**Re: Council File 14-0171
Planning and Land Use Management Committee Hearing February 25, 2014,
Agenda Item 5; Council Hearing February 26, 2014, Agenda Item 7;
Important Items in the Record (Letter #1) concerning
50-FOOT HEIGHT VARIANCE AT 10550 W. BELLAGIO ROAD –
Case No. ZA 2012-1402-ZV-ZAA-ZAD-1A**

Re: Case No. ZA-2012-1402-ZV-ZAA-ZAD; CEQA No. ENV-2005-8611-MND –
10550 Bellagio Road – Hearing September 25, 2013

Re: Case Nos. ZA-2012-1402-ZV-ZAA-ZAD, ENV-2005-8611-MND
(10550 Bellagio Road) - Hearing on September 25, 2013

**RE: PLANNING DEPARTMENT FILE -- JUSTIFICATION TO DENY PROJECT
REQUEST – ZA 2012-1402-ZV-ZAA-ZAD.**

RETAINING WALL EXHIBIT 10550 BELLAGIO ROAD BEL AIR, CA		SHEET NO. 6411
CITY OF LOS ANGELES		
DRAWN BY DATE	CHECKED BY DATE	PROJECT NO. DATE
SCALE 1" = 20'		
ENGINEERING GROUP, INC. 10550 BELLAGIO ROAD BEL AIR, CA 90005

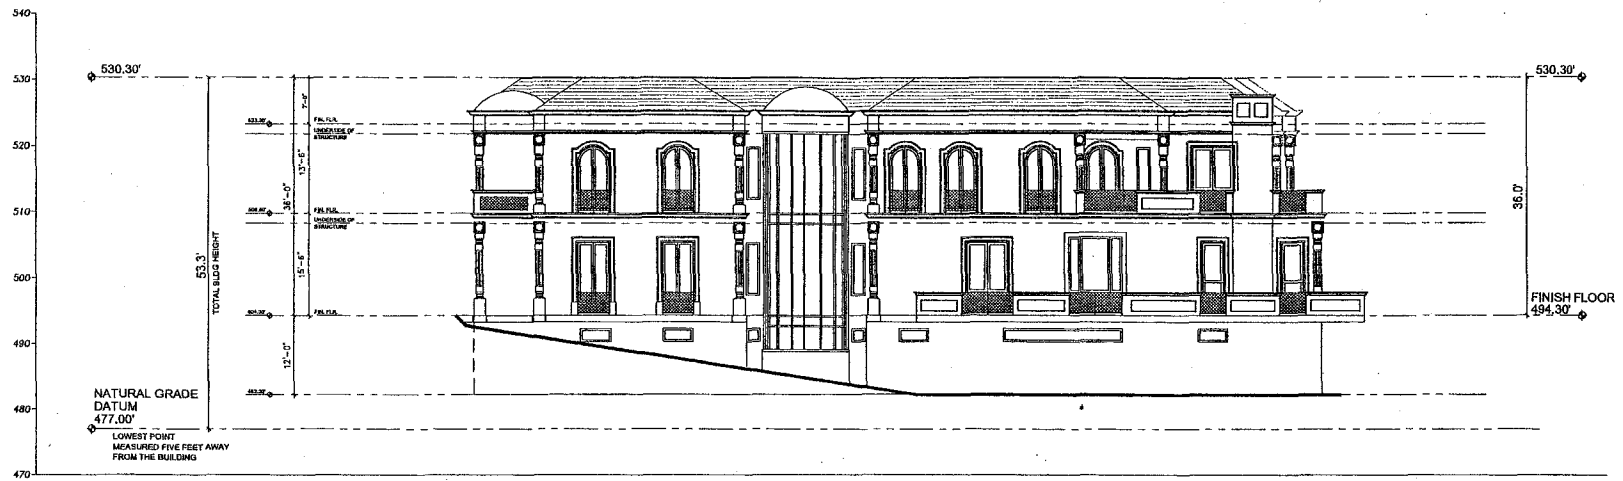
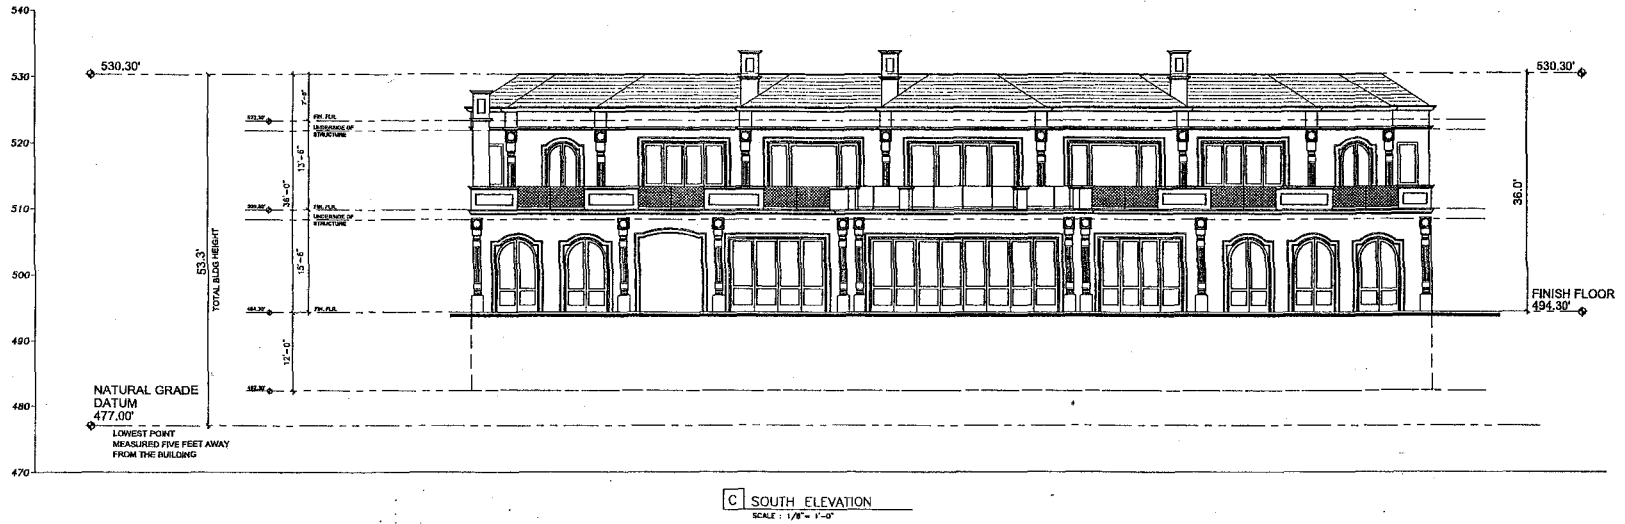
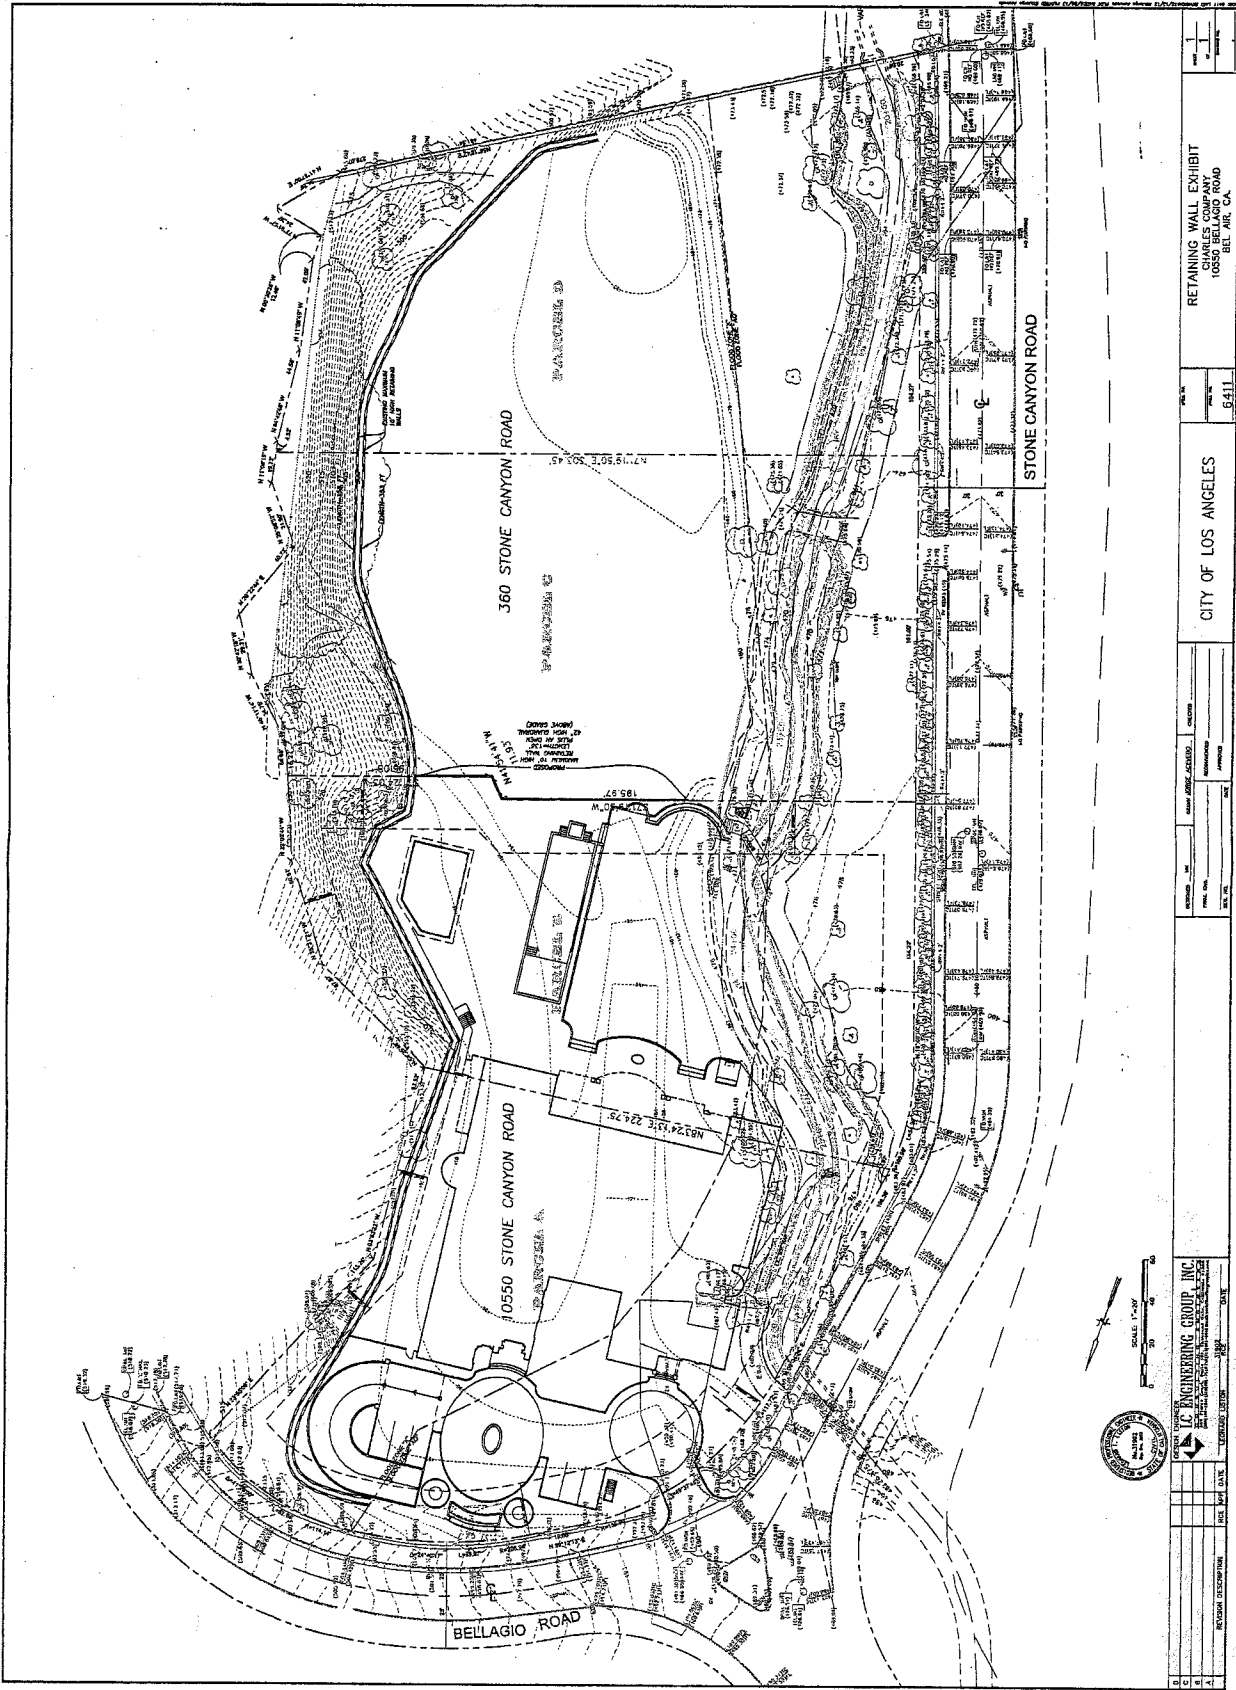
I have visited the site and reviewed the elevations and other drawings submitted by the applicant. Missing from the applicant's submittals is a plot plan. I believe that the request for the zone variance in this Case is not complete without a plot plan for both the Zoning Administrator and the public to assess. However, the application package does contain a drawing entitled "Retaining Wall Exhibit" and, although this drawing does not include much of the information typically found on a plot plan, it does show the outline of a house and some of the other improvements proposed for the site.

In reviewing available information for the house from your file (Retaining Wall Exhibit and Elevations -- Exhibit A), we find it unusual that the owner of such a house would put the equipment in an area that would require access through the house. This is not typical of high-end estates these days. Owners want equipment in areas where service personnel do not intrude into personal and living areas. We see many systems installed in basements with some equipment in the yard. To avoid seeing equipment in yards, some clients will disguise the area with landscape and trellises, or build underground vaults, which we have been using a lot lately and are seeing more of in this industry.

EXHIBIT C

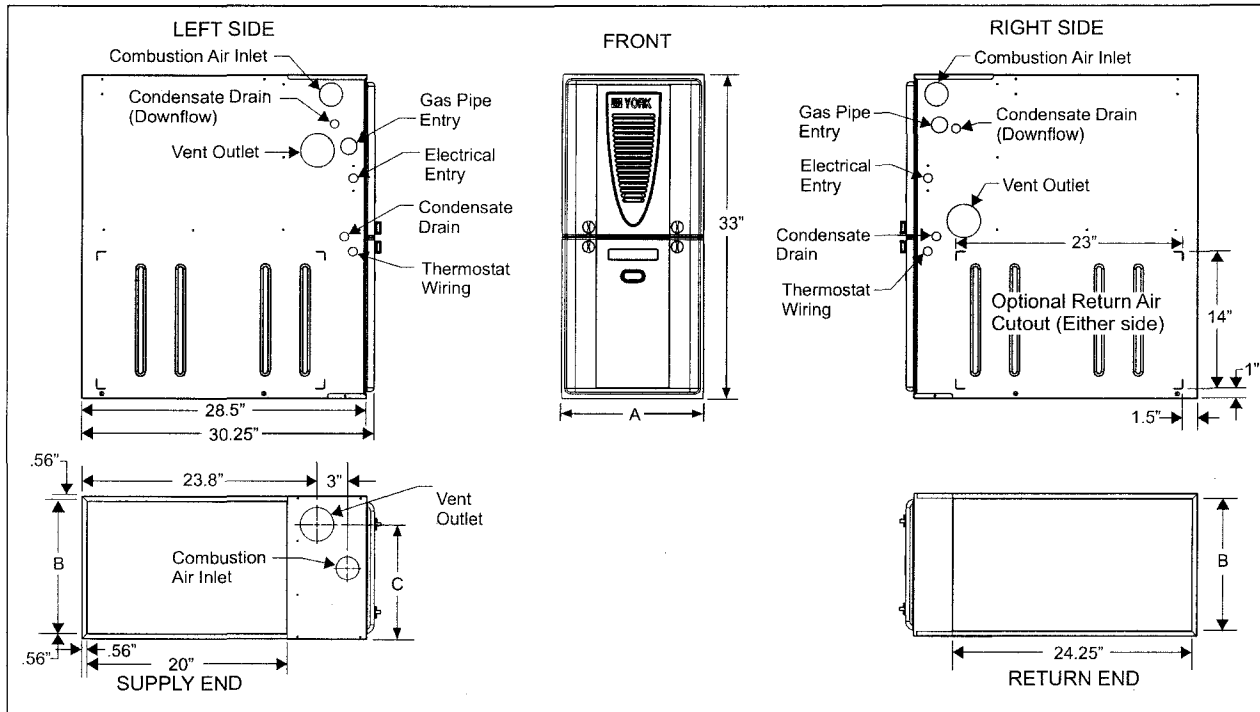
Attached (exhibit C) is the specification of a York 98% efficiency gas-fired furnace and is closely related to the other manufacturer's furnaces. The 2010 CMC requires 30" on the electrical side of the system for access, but references the manufacturer's physical data to provide enough height to properly service and remove the furnace if necessary. If installed horizontally, the height of this unit is only 21" and if it's within 10 feet of sink, the unit only needs an additional

3" for the condensate drain slope. We always hang the furnace from the roof joist using 1/8" rods with spring isolators; this adds about 12" on average. This all adds up to a vertical space requirement of only 36" for these furnaces.
